## **Ward Valley: An Examination of Seven Issues in Earth Sciences and Ecology**

Committee to Review Specific Scientific and Technical Safety Issues Related to the Ward Valley, California Low-Level Radioactive Waste Site, National Research Council

Committee to Review Specific Scientific and Technical Safety Issues Related to the Ward  
Valley, California, Low-Level Radioactive Waste Site  
Board on Radioactive Waste Management  
Commission on Geosciences, Environment, and Resources  
National Research Council

**Figure 5.1** Postulated ground-water pathways from the Ward Valley ground-water basin to the Colorado River (Wilshire et al., 1994). Gray indicates mountains; cross-hatching denotes valleys.

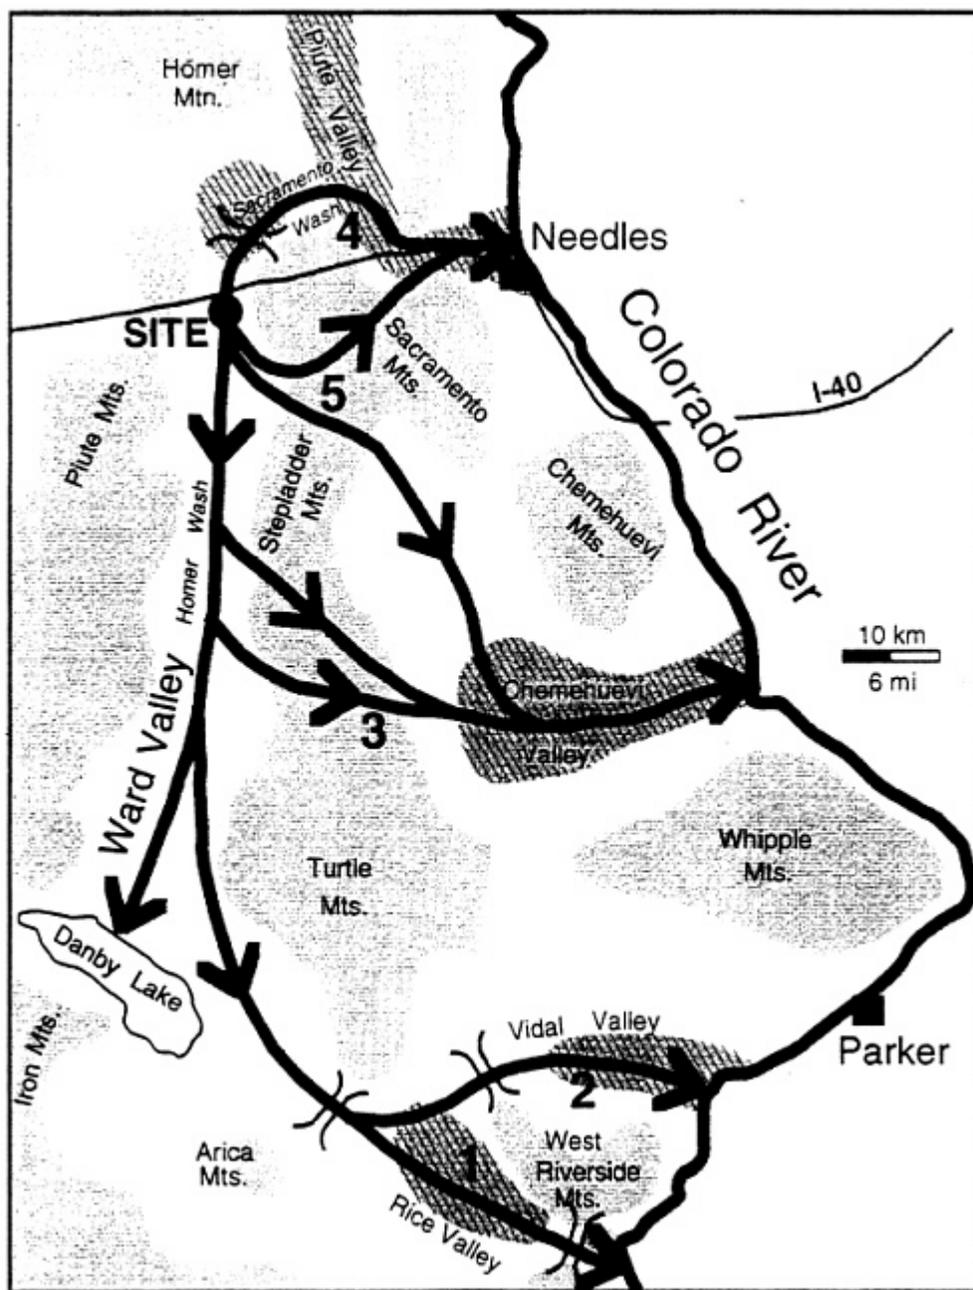
Routes 1 and 2 (Rice Valley and Vidal Valley): These routes are possible because of an apparent continuity of permeable alluvial materials from Ward Valley through Rice and Vidal Valleys. Arguments that a ground-water divide exists beneath the topographic divide in the region leading to Rice Valley are not supported by any reliable water level data. Well-survey data (LA Figure 2420.A-4) indicate water levels in the area that are lower than the water levels at Danby Dry Lake, therefore indicating a hydraulic gradient that could drive flow towards Rice and Vidal Valleys. Because the water-level data date back three to eight decades, however, their reliability is uncertain. Although no information precludes a groundwater divide, its presence cannot be substantiated with the current data.

Based on [Figure 5.1](#) (from Wilshire et al., 1993) showing postulated pathways to the Colorado River, routes 1 and 2 are approximately 130 km long (through the Rice or Vidal Valleys). The other possible pathway is the Wilshire group's route 3 eastward beneath the hills at the south end of the Stepladder Mountains. The approximate length of that pathway is 80 km from the proposed site to the Colorado River.

**Figure 6.1** Schematic diagram of trench cover and monitoring islands. Inset: Detail of monitoring island (U.S. Ecology, 1991) (Distances not converted to metric system.)

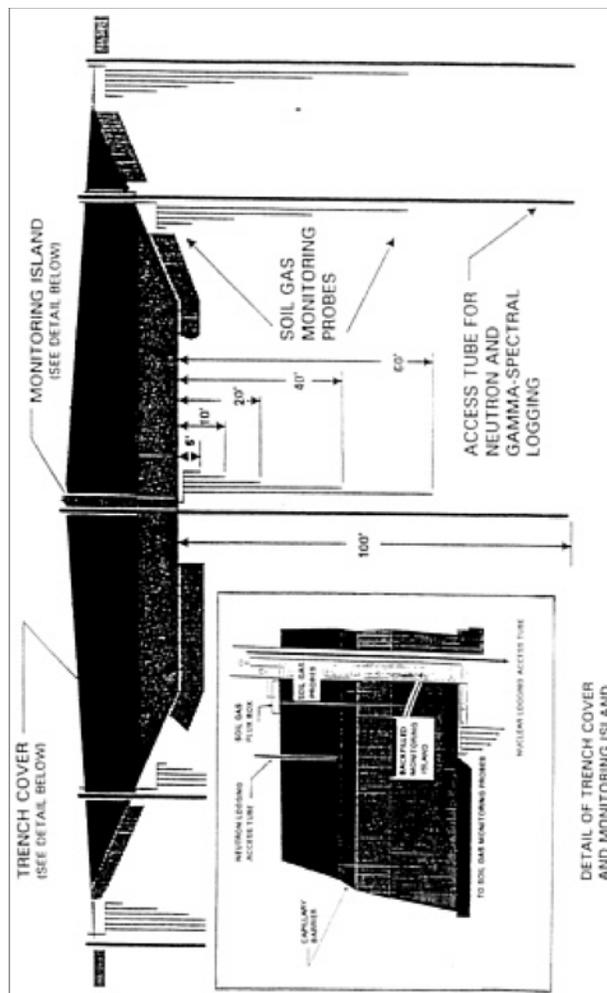
- As federal regulations provide investigation and action levels for compliance monitoring, but not for performance monitoring in the unsaturated zone, the committee strongly recommends developing and documenting investigation and action levels for monitoring in the unsaturated zone. In the unlikely event of contaminant movement through the unsaturated zone, it is not prudent to wait for contaminants to reach the compliance boundary before investigating the contaminant movement and developing an action plan.

**Figure 7.4** Schematic plan view of temporary breakup berms.

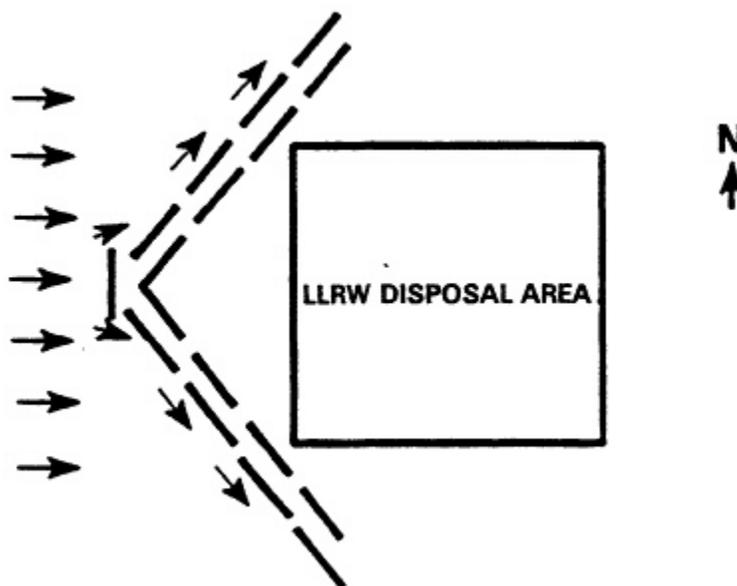
- **The proposed system of shallow ridges (or flow break-up hems) to be built of natural site material and placed upslope from the waste facility site in a chevron pattern, to provide roughness to reduce the velocity of water coming off the fan toward the site, will likely be eroded and breached over a period of decades but will probably continue to function to provide the desired flow resistance for several additional decades, and will have no impact on the stability of the site.**
- **In the committee's opinion, concerns over possible floodwater ponding along the upstream edge of the flood protection berm and possible water seepage through the berm and into the trench area can be effectively ameliorated through easily-engineered defensive measures.**

Offsite storm water flows onto the LLRW site from the west as sheet flow or in small rills. A series of shallow-flow breakup berms will be placed in a staggered, offset chevron pattern upslope and west of the disposal facility, (Figure 7.4), primarily (1) to increase sheet flow roughness for the purpose of reducing the sheet flow velocity and inducing more tranquil subcritical hydraulic conditions near the permanent primary flood control berm to reduce scour potential, and (2) to divert storm runoff to the north and south of the facility (LA Section 3310.2). Each berm that forms part of the chevron pattern would be 122 m long, 3 m wide and 0.3 m high. These shallow flow breakup berms, however, are intended to be temporary features that will be constructed during the initial trench excavation with materials removed from the trenches and maintained during the operations and institutional control periods. A more detailed analysis of the breakup berms is discussed later in this chapter.
